STRUCTURAL EVALUATION OF  
PORTOLA MIDDLE SCHOOL  
WEST CONTRA COSTA UNIFIED SCHOOL DISTRICT  
(WCCUSD)

October 17, 2002

DASSE Design Project No. 01B300x2

Drawing 1: Main Classroom Building ground floor plan

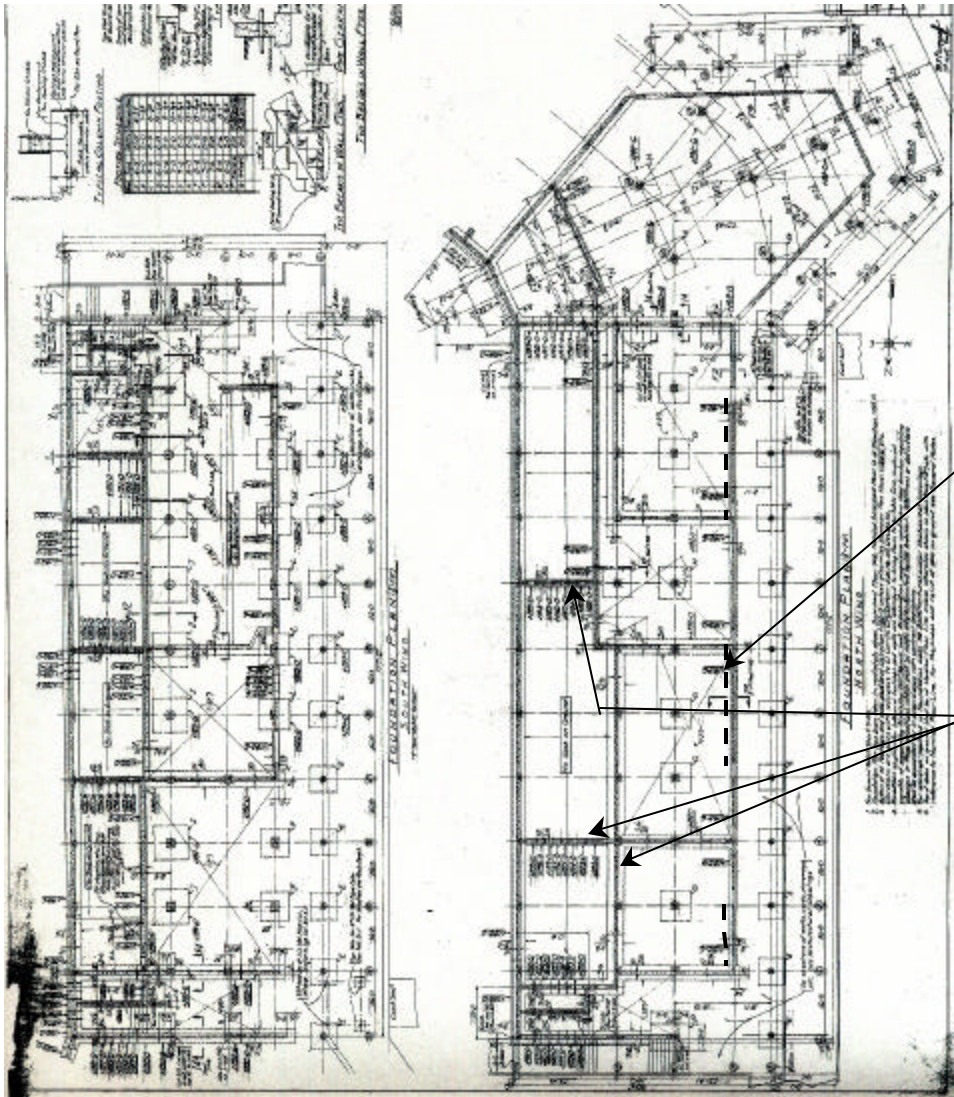
3.	At the north wing of the main building, the west basement wall is partial height and therefore is not connected to the first floor slab. The center of rigidity of the building at the basement level is dominated by the walls on the east side of the building, inducing a lot of torsion into the building at this level

3.	Infill 80 ft length of the western partial-height 8" thick shear wall to make it a full-height wall. Dowel into existing wall.	1.9	1
4.	Provide a new steel plate at the exterior of the building bolted back into the existing walls to restrain the concrete from spalling off. 4 locations x 6 ft of 24" x 1" plate and two rows of expansion anchors at each location.	2.2	3

Drawing 2: Main Classroom Building first floor plan

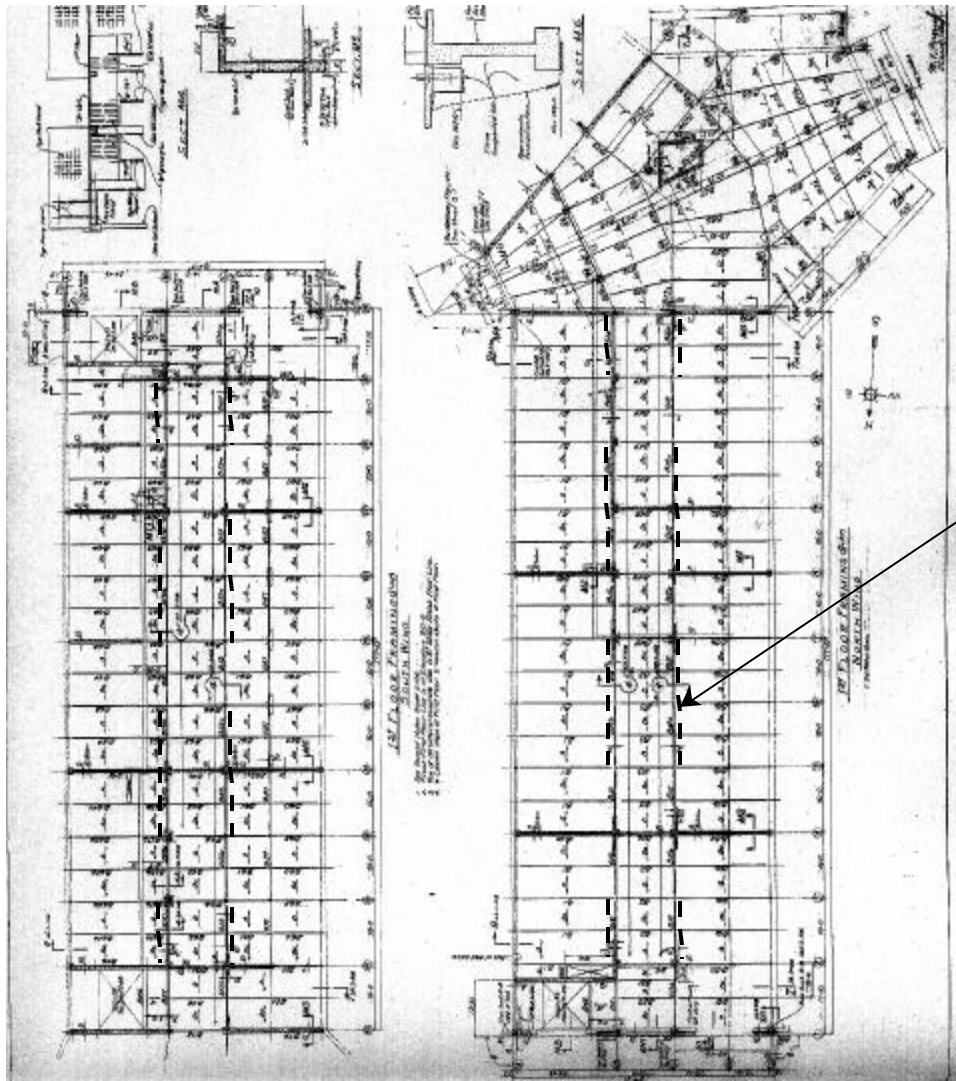
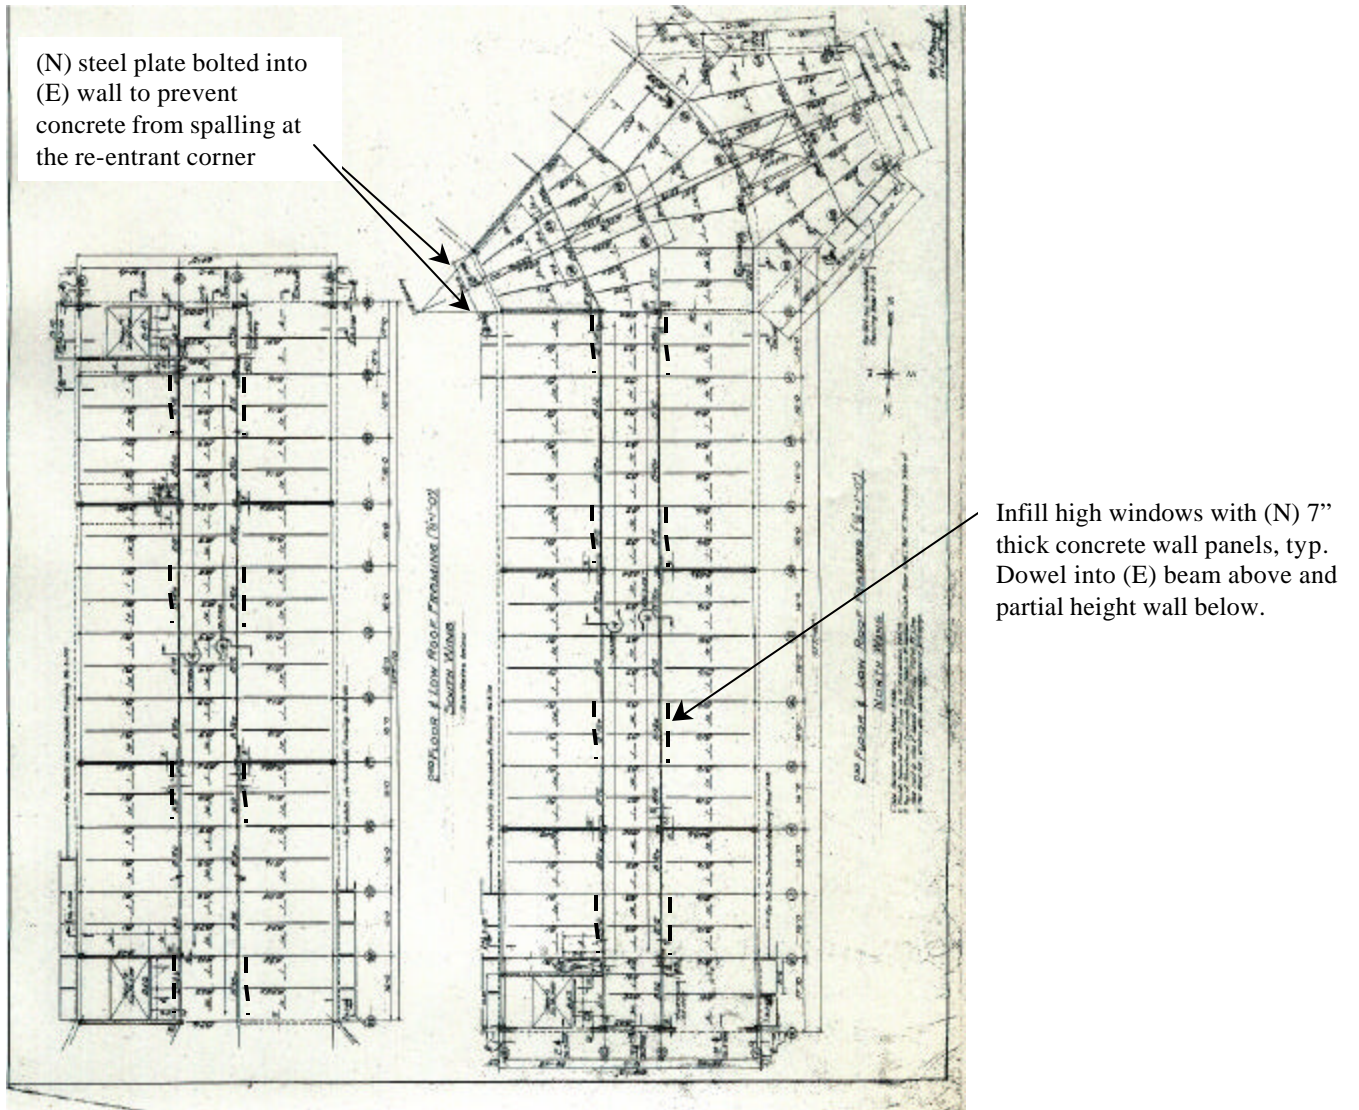
2.	At the main building, there are short columns between the partial height wall and slab at 1st and 2nd stories that create high windows along the corridor. These elements are flexible relative to the walls and do not have sufficient capacity to resist the seismic loads. Furthermore, the columns are shear-critical, and therefore will have non-ductile behavior.

2.	Infill some of the high windows with new concrete wall panels. Provide new 7" thick concrete wall, 64 ft at the 2nd floor, 96 ft. at the 1st floor at interior corridor walls in each wing	1.0	2,3

Infill high windows with (N) 7" thick concrete wall panels, typ. Dowel into (E) beam above and partial height wall below.

Drawing 6: Gymnasium Building roof plan

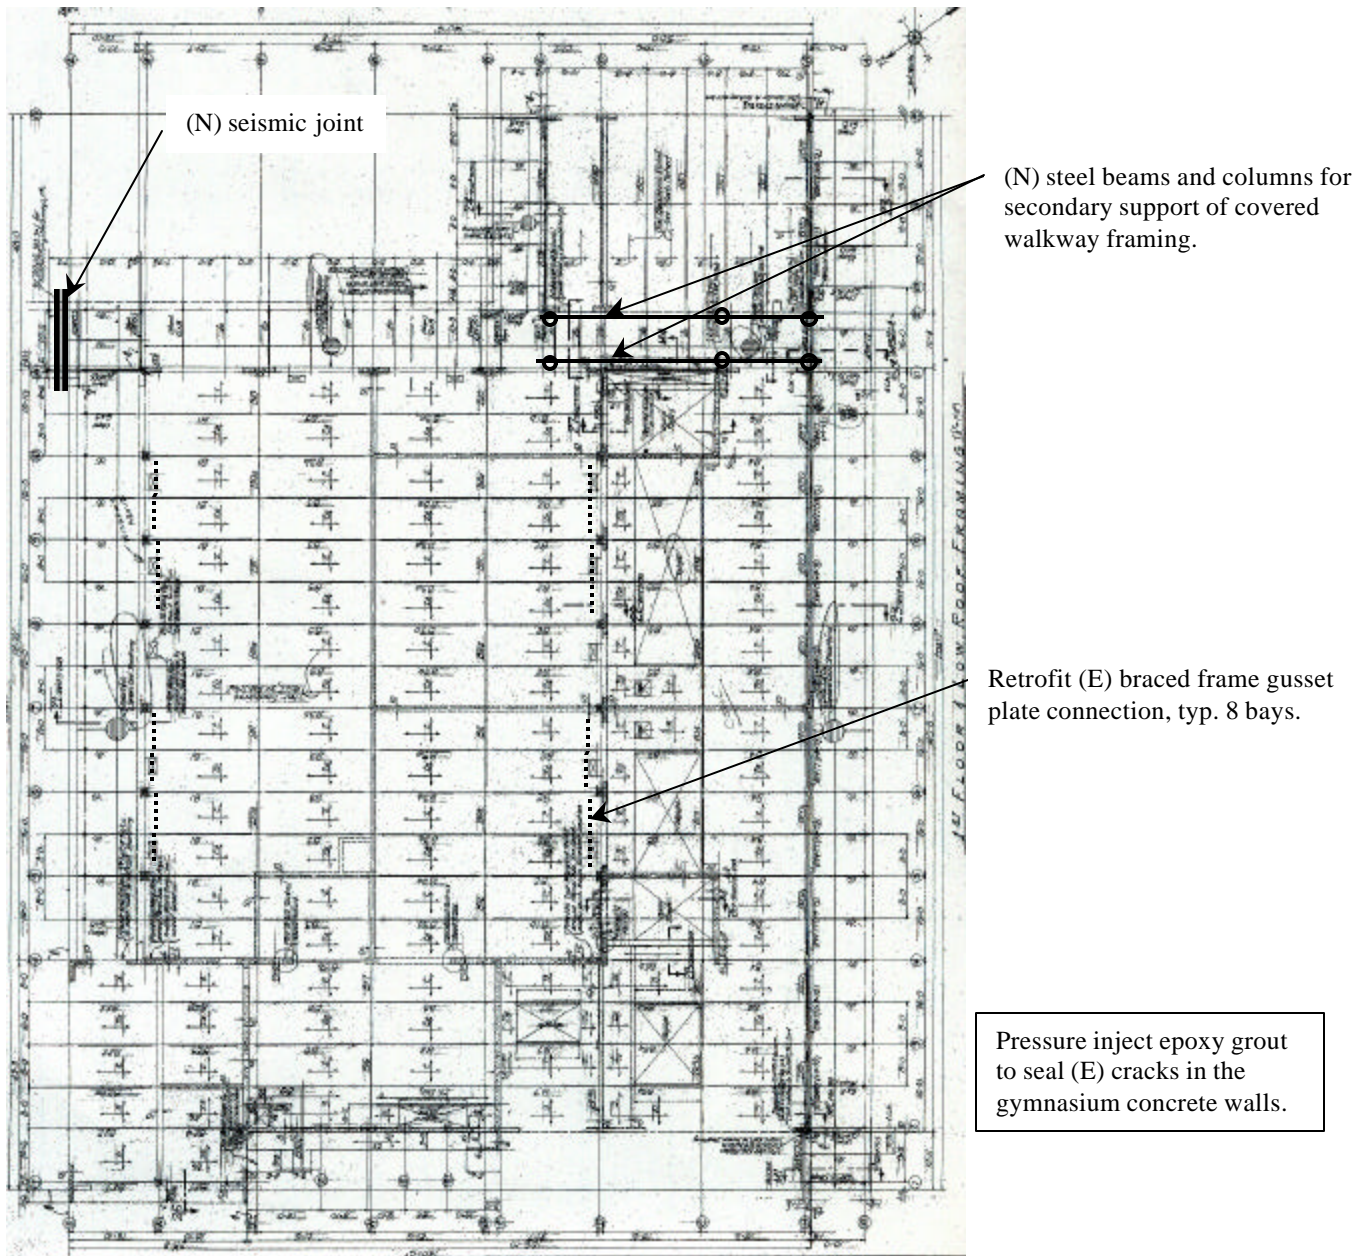
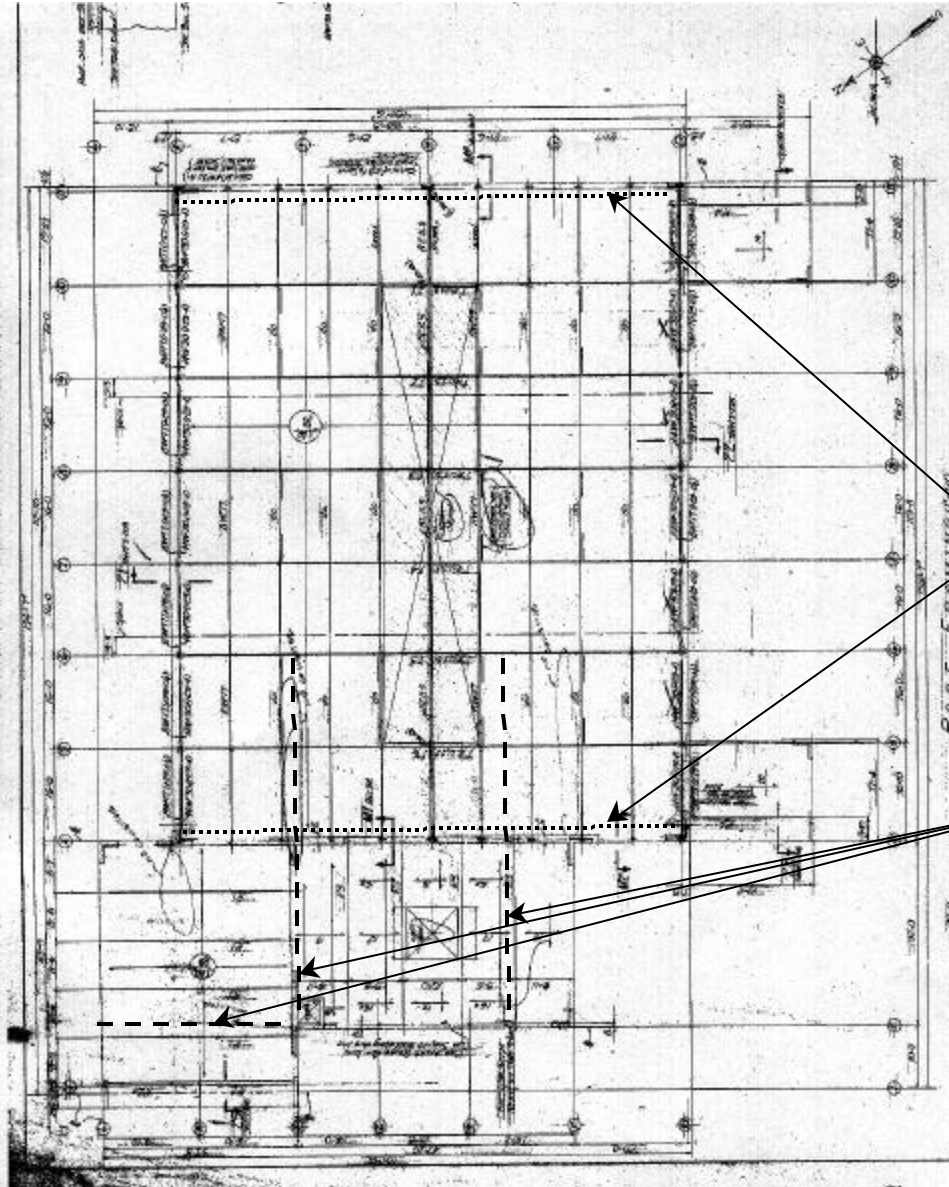
7.	There is a lack of collectors at the roof of the Gymnasium building where the east and west walls of the stage area provide additional lateral support for the main gym area roof and where the north wall of the stage area provides additional lateral support for the music room roof.

8.	The north and south walls of the gymnasium may have inadequate capacity to span vertically between the first floor and roof under seismic loading
9.	There are some minor cracks in the concrete walls of the gymnasium.

7.	Provide new concrete collector elements aligned with the stage area walls that tie into the existing concrete roof slab.	1.4	6
8.	Provide new bracing of the walls back to the roof diaphragm to cut down the wall span.	1.0	6

(N) bracing from the concrete walls up to the roof slab to reduce the wall's vertical span for out-of-plane forces.

(N) concrete or steel collector elements tied into the (E) walls and roof slabs.

Drawing 7: Laboratory Building roof plan

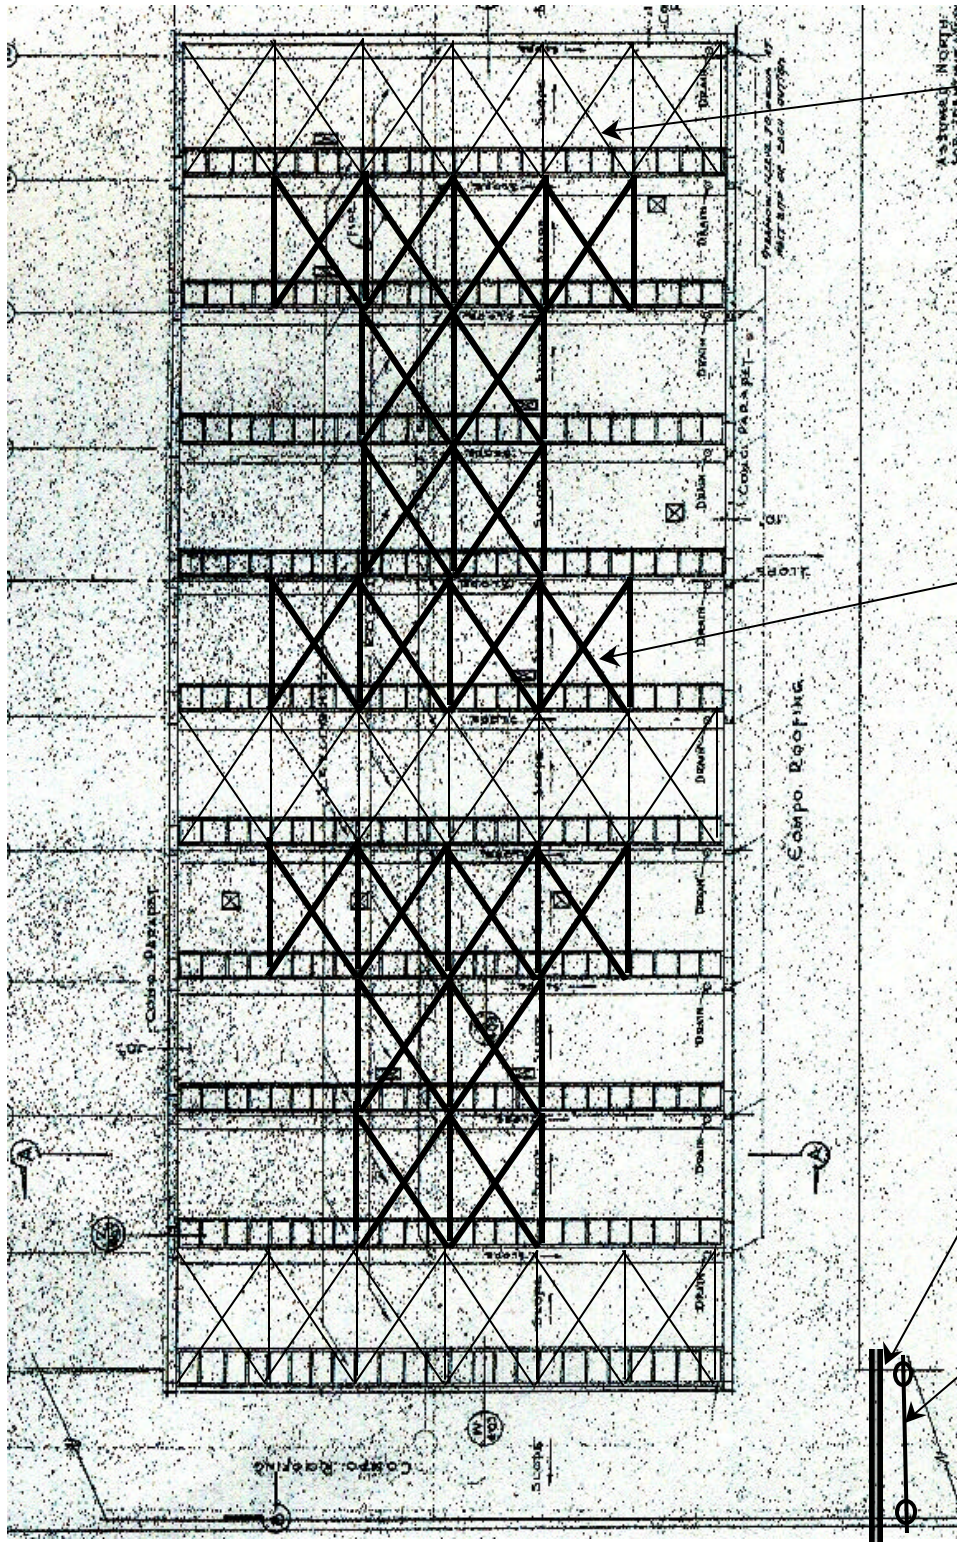
11.	At the laboratory and shops buildings, the diagonal roof bracing is inadequate to transfer the seismic forces to the transverse wall lines.
12.	The covered walkway between the Gymnasium and Laboratory Building are connected at each end to buildings. As the buildings move independently, the walkway may tear away and collapse.

13.	Long sections of covered walkways are connected to the adjacent buildings. Because the buildings are much stiffer than the canopy supports, the load will be carried by the building, increasing both the building base shear and the collector

9.	Pressure inject epoxy grout to seal the cracks.	3.0	5
10.	Provide new columns for secondary gravity support of the covered walkway.	1.1	5
11.	Provide additional diagonal bracing similar to existing bracing OR replace existing bays of angle braces with new double angle braces. 14 braces at lab building, 28 (estimated) at shops building.	1.3	7

12.	Provide supplemental support adjacent to each building so that damage will not lead to the collapse of the walkway. Reroute conduits and piping so that it is not supported by covered walkways or has adequate flexible connections	1.1	7

13.	Provide seismic joints in the existing covered walkway.	1.6	7

(N) diagonal bracing at the roof horizontal truss level, typ. Remove existing bracing as required.

(N) seismic joint

(N) steel beams and columns for secondary support of covered walkway framing.
